APPEAL SUMMARY

Appeal ID: 23426

Project Address: 9551 SW 62nd Dr

Proposed use: ADU

JOHNSTONE BASEMENT BATHROOM / BEDROOM RENOVATION BUILDING CODE APPEAL CLARIFICATION:

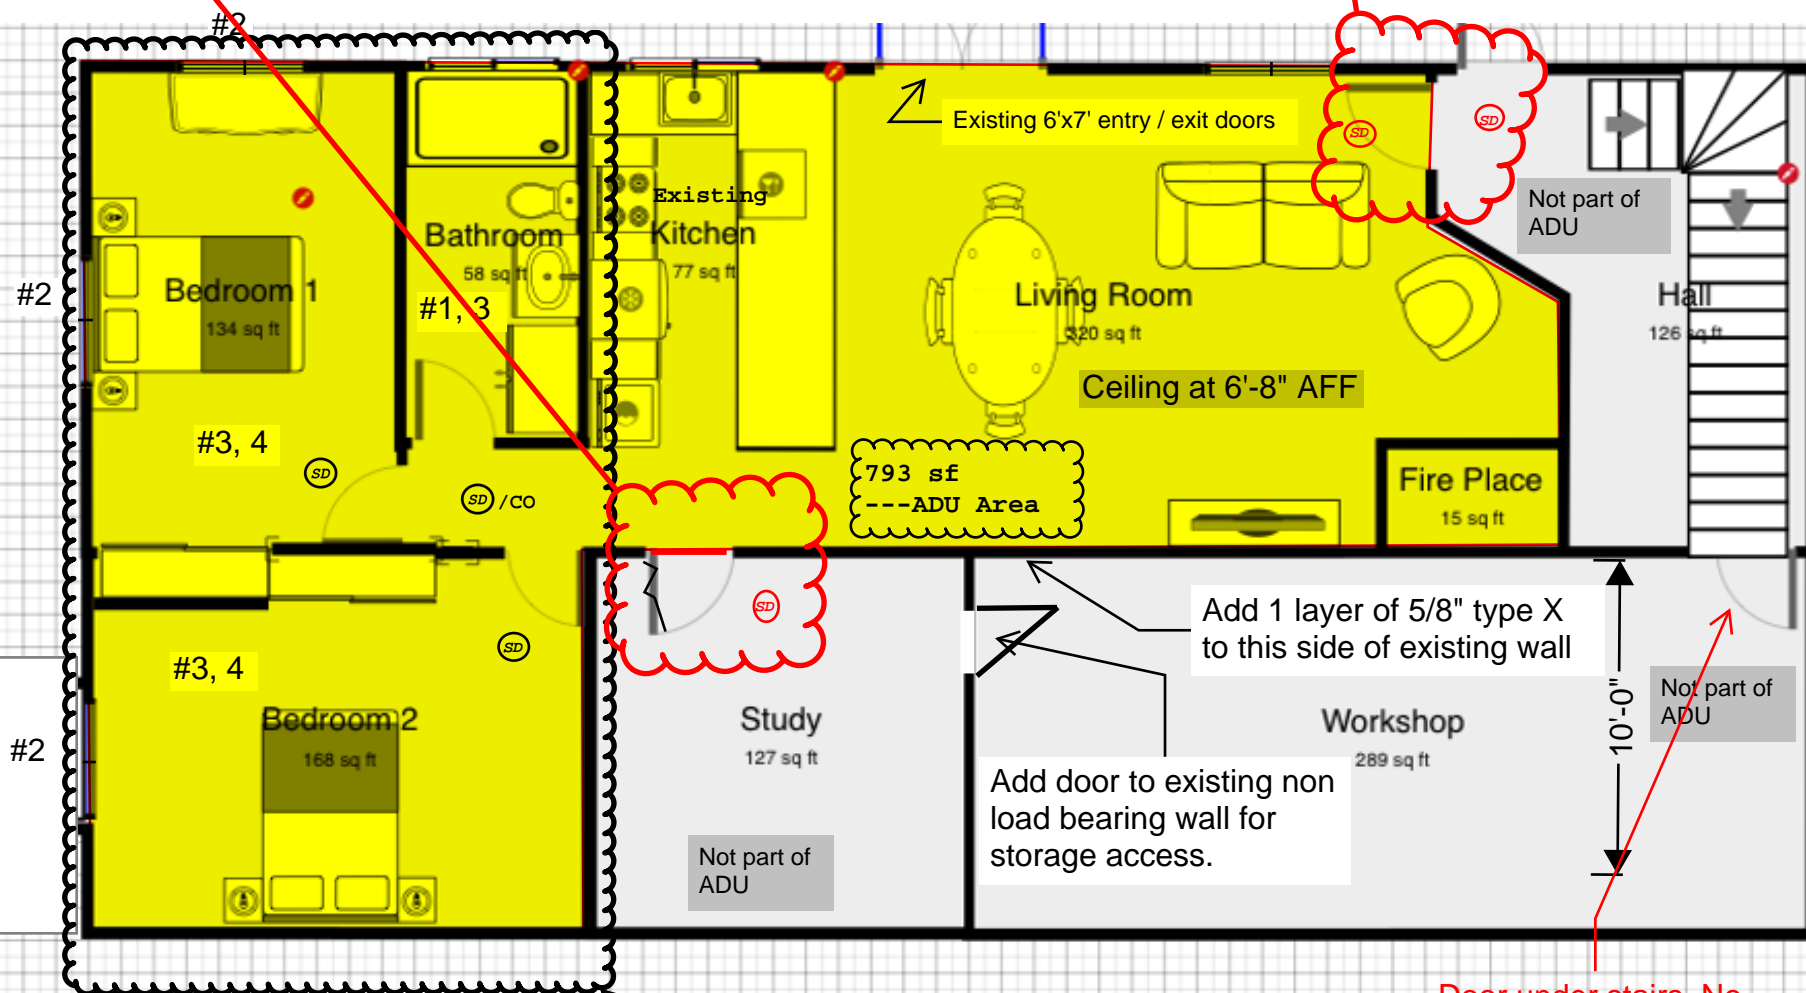
#1 Remove door and infill opening

#2. Replace existing door with one of 20 minute fire rating for access to the basement area when space is not being used as an ADU. Door to remain locked with dead bolt when space is ADU occupied.

#1 - Remove door and infill opening

#2 Replace existing door with solid core 20 minute rated

ADU with 1 communicating door into main unit: Granted provided the door from the hall into the ADU is 1 hour rated.

JOHNSTONE BASEMENT BATHROOM / BEDROOM RENOVATION BUILDING CODE APPEAL CLARIFICATION:

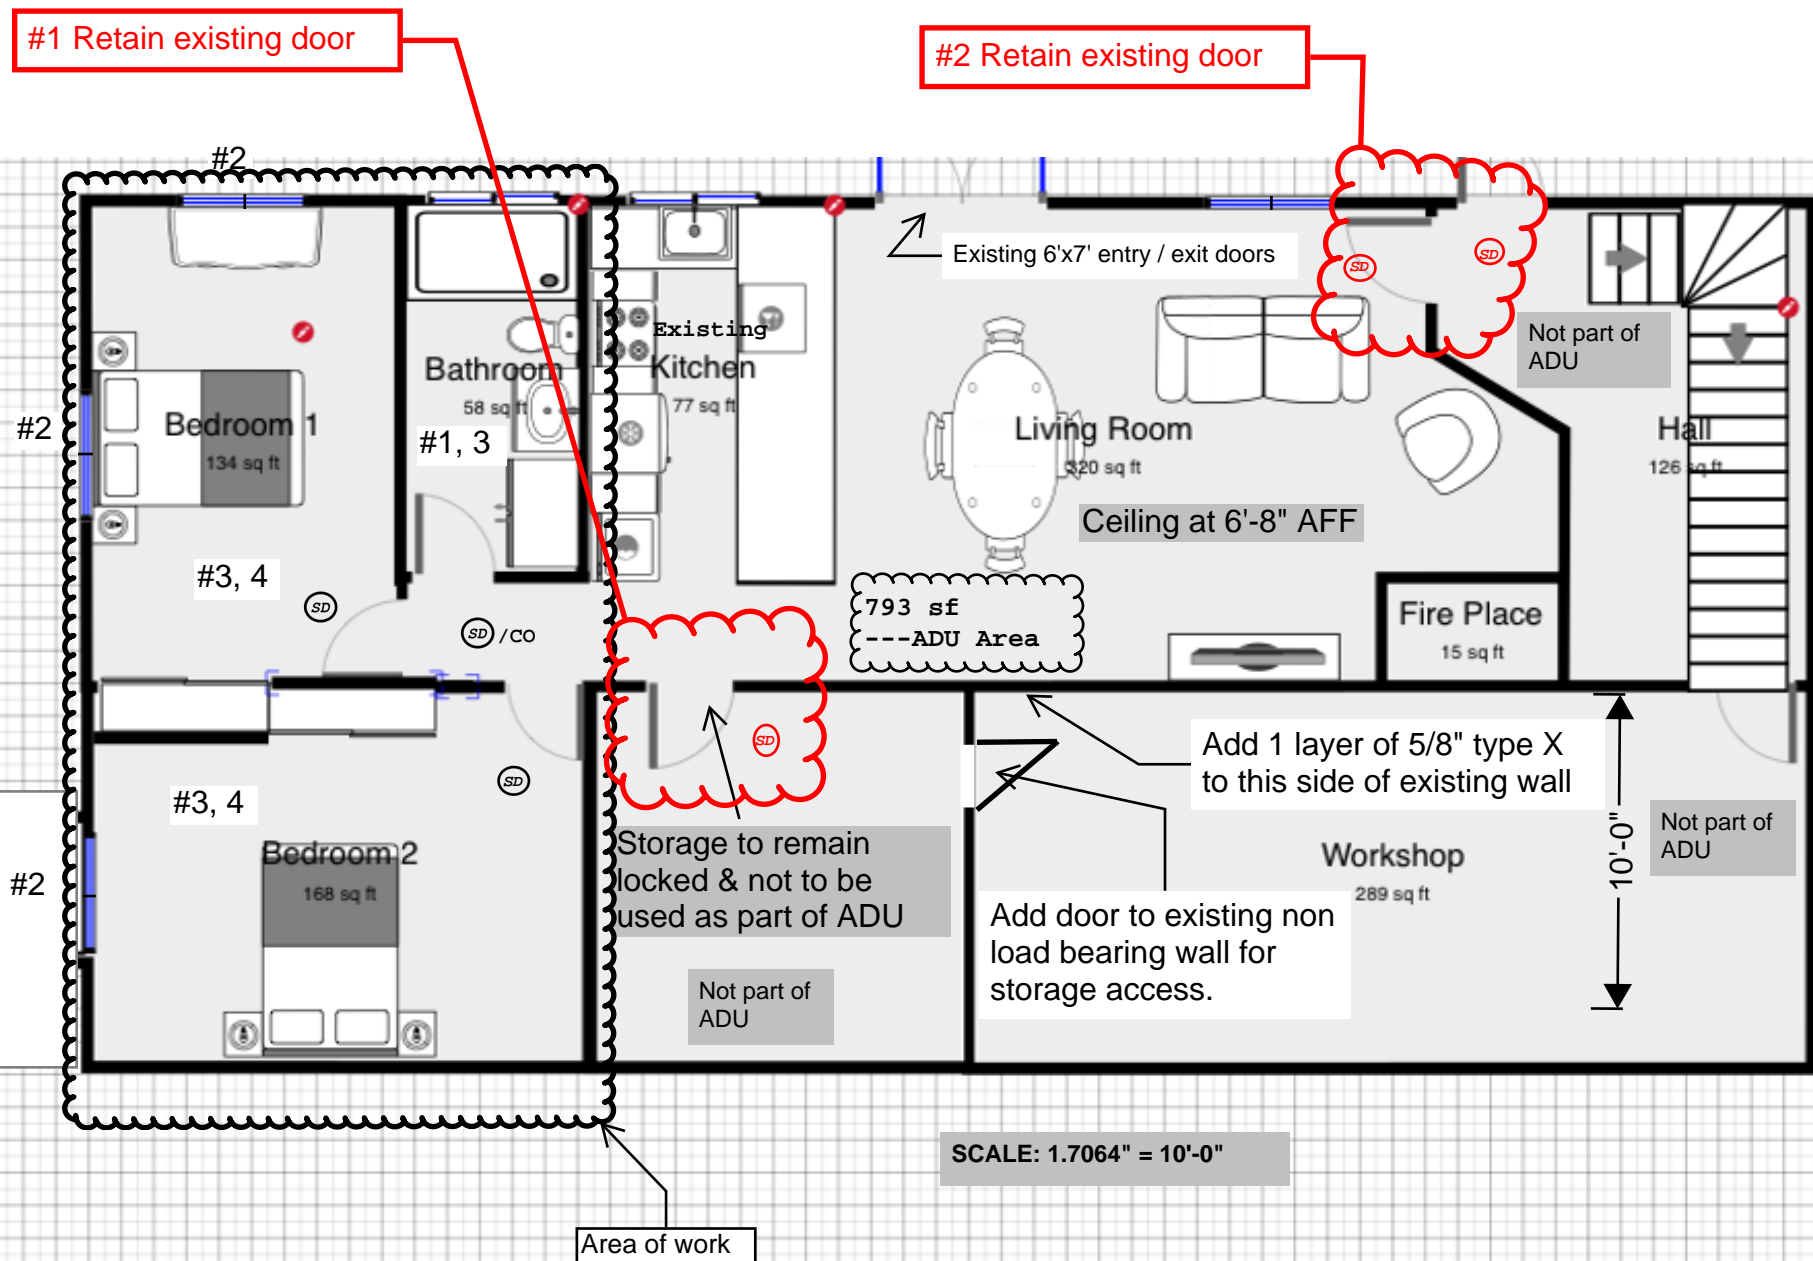
#1 Retain solid core door to storage room and add dead bolt to door to remain locked during ADU occupancy.

#2. Retain existing solid core for access to the basement area when space is not being used as an ADU. Door to remain locked with dead bolt when space is ADU occupied.

JOHNSTONE BASEMENT BATHROOM RENOVATION DETAILS:

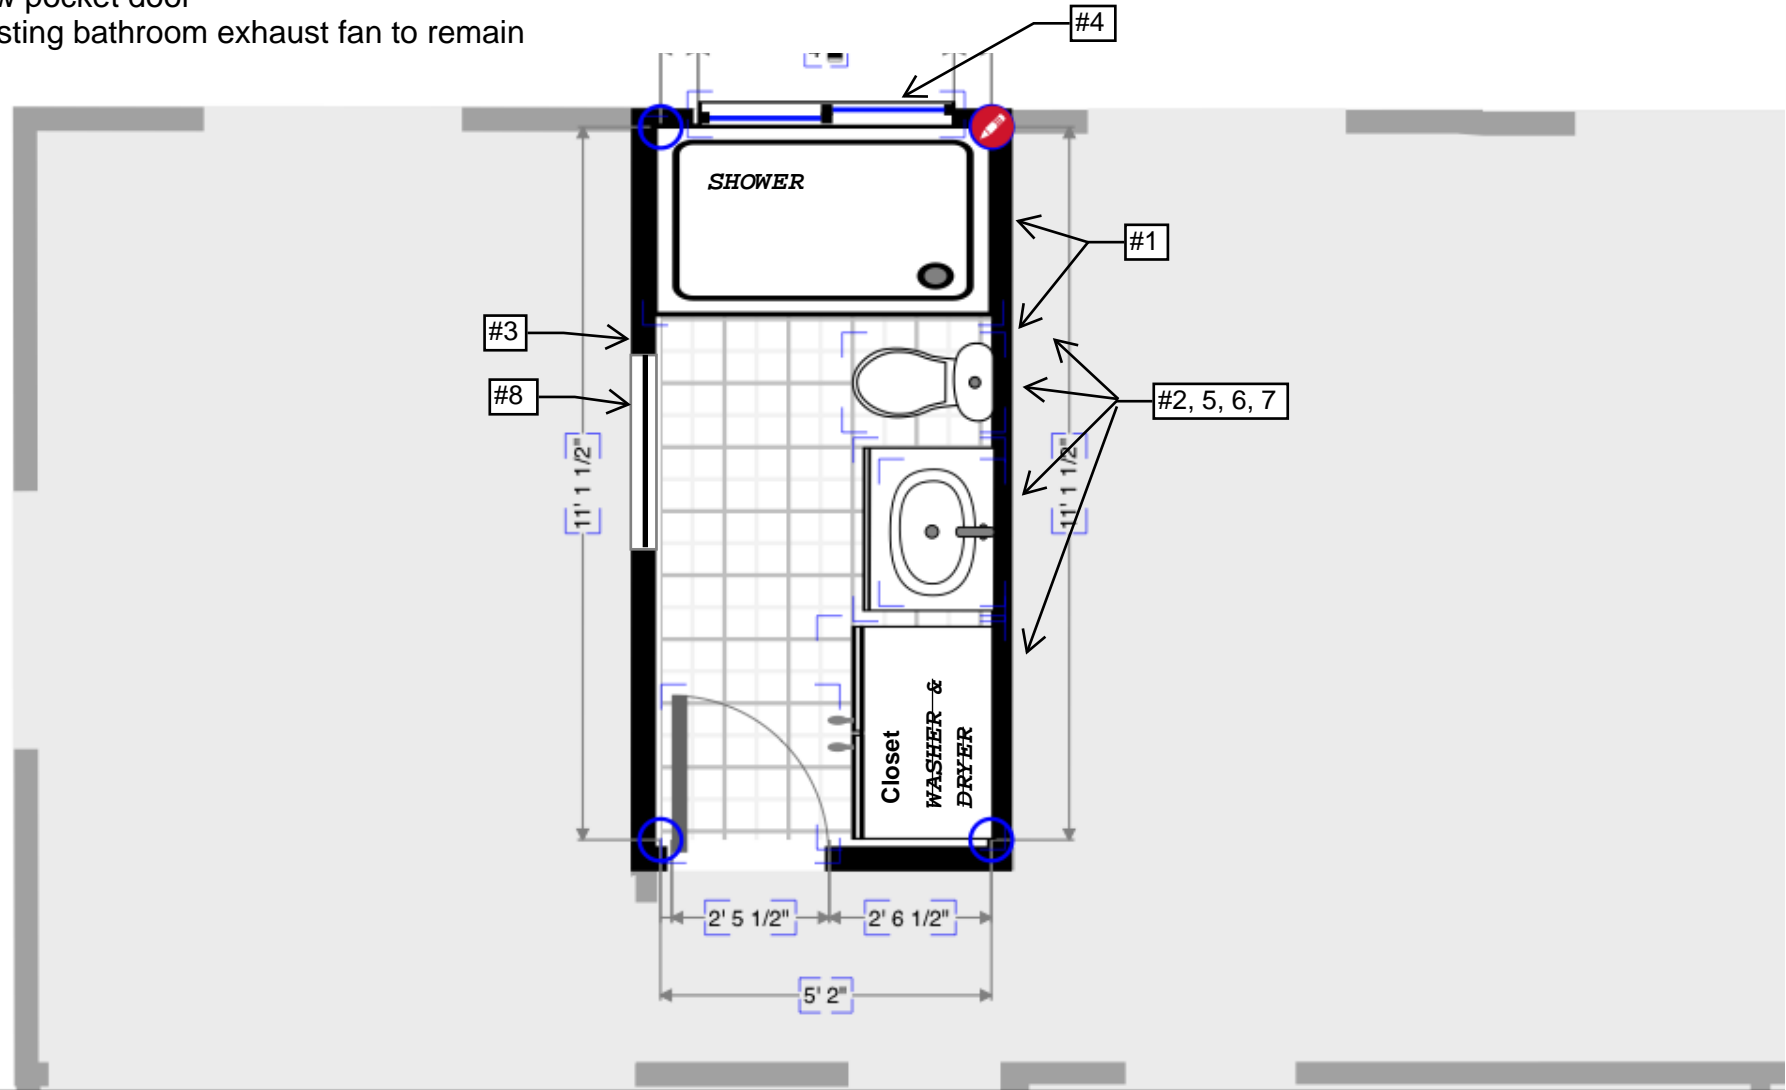
**#2 Existing solid core door to enter ADU
at the bottom of the stairs**

#1 Existing solid core door to storage room

Ground (1st) floor renovation
permitted 14-149495 RS

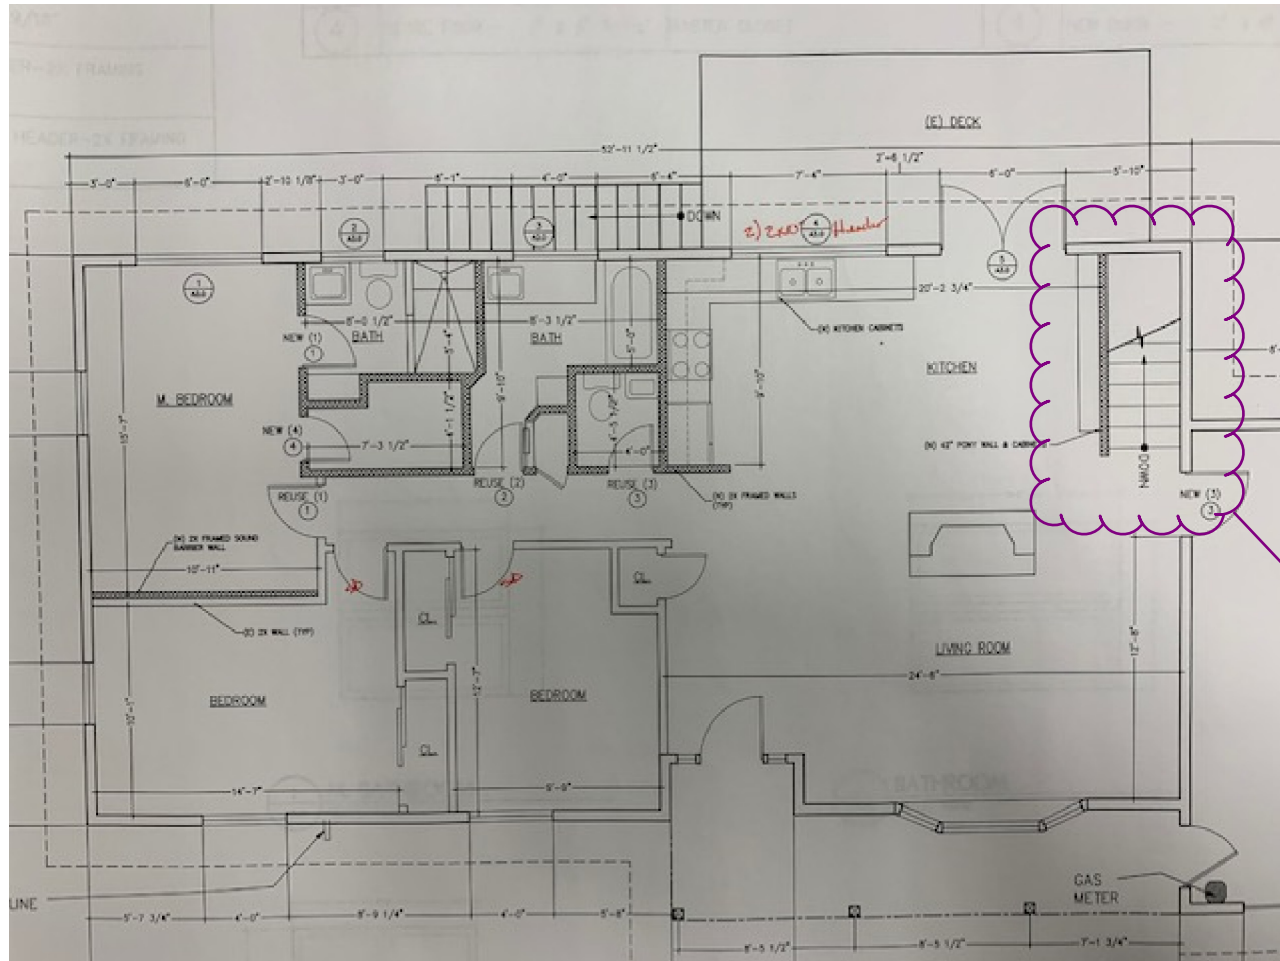
Stair well open to below. No full height wall or door retained in this location.
